TITLE : AIR CONDITIONING - PRESSURE CONTROL AND MONITORING - INTRODUCE PRESSURE  
CONTROLLER PN 9022-15702-10

MODIFICATION No. : 28009K5801

This page transmits Revision No. 04 of Service Bulletin No. A320-21-1116.

SERVICE BULLETIN No. : A320-21-1116

Figure 1 Sheet 1  
Removal/Installation of the Cabin Pressure Controller

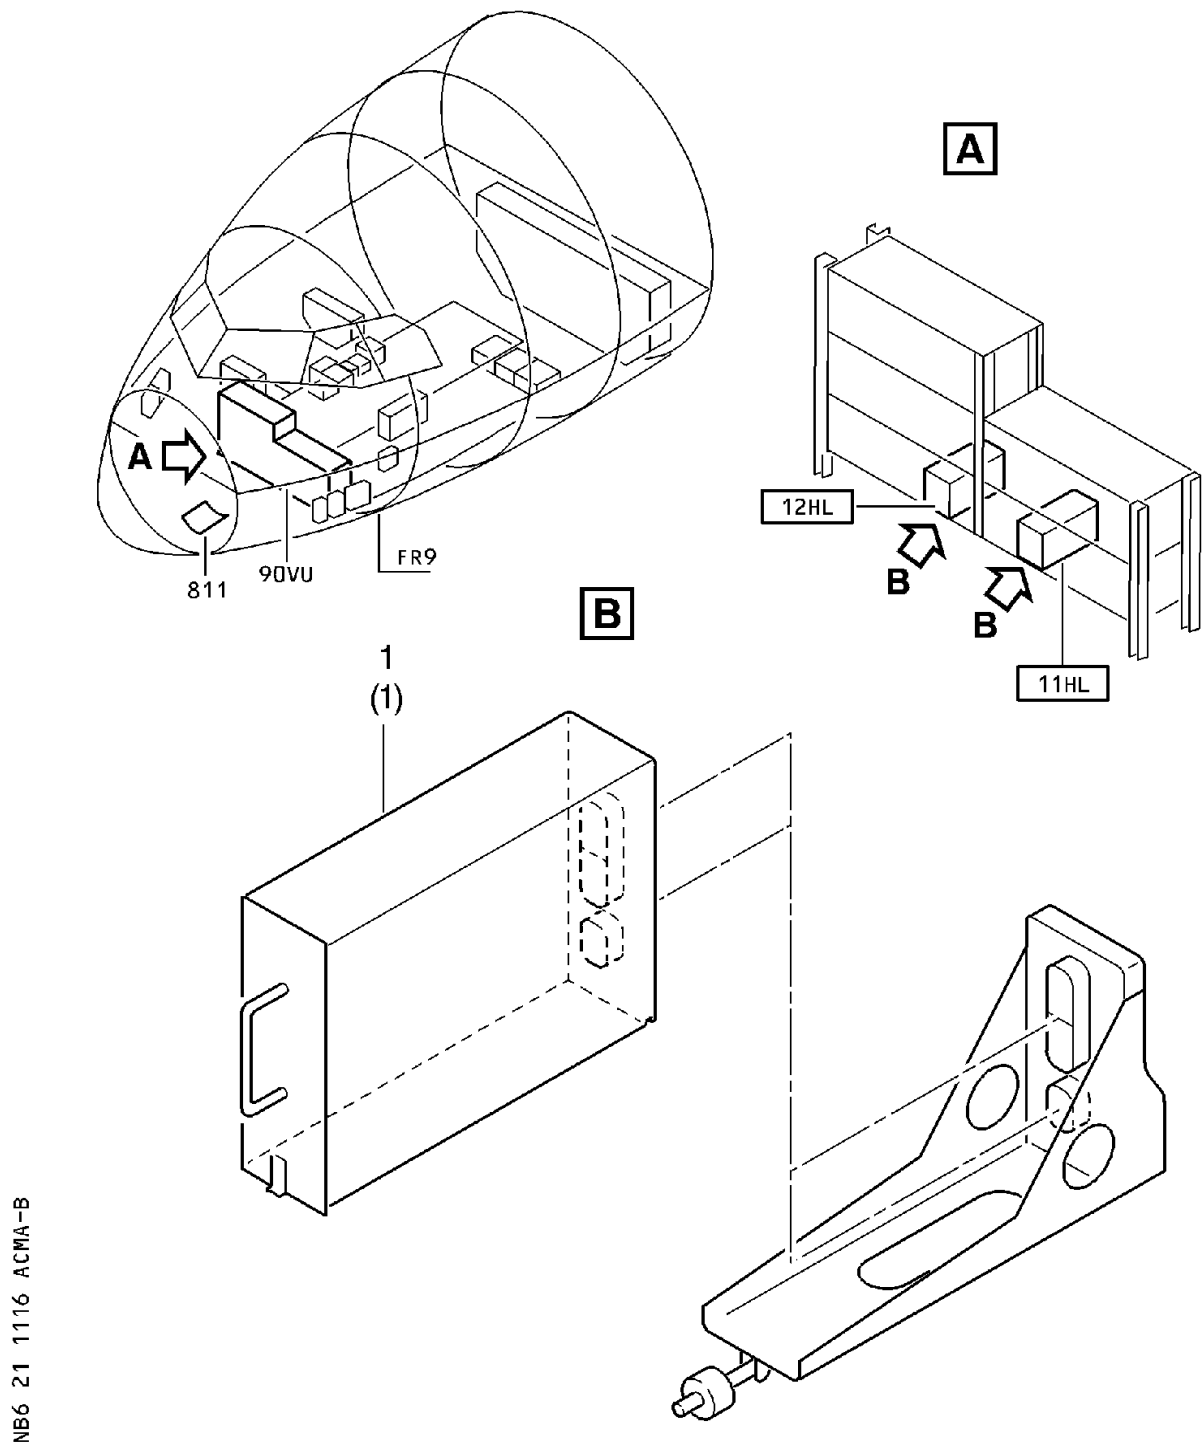
- (1) Remove the Cabin Pressure Controllers 11HL and/or 12HL PN 9022-15702-7, 9022-15702-7A, 9022-15702-8 or 9022-15702-9, item (1), refer to AMM 21-31-34 Page block 401 and refer to Figure 1 .

- (4) Install the Cabin Pressure Controller 11HL and/or 12HL, item 1, refer to AMM 21-31-34 Page block 401 and refer to Figure 1 , Sheet 1 .

**NOTE** : If mixed configuration is required :

- make sure that the CPC PN 9022-15702-7, 9022-15702-7A, 9022-15702-8 or 9022-15702-9 is installed on channel 1,
- make sure that the CPC PN 9022-15702-10 is installed on channel 2.
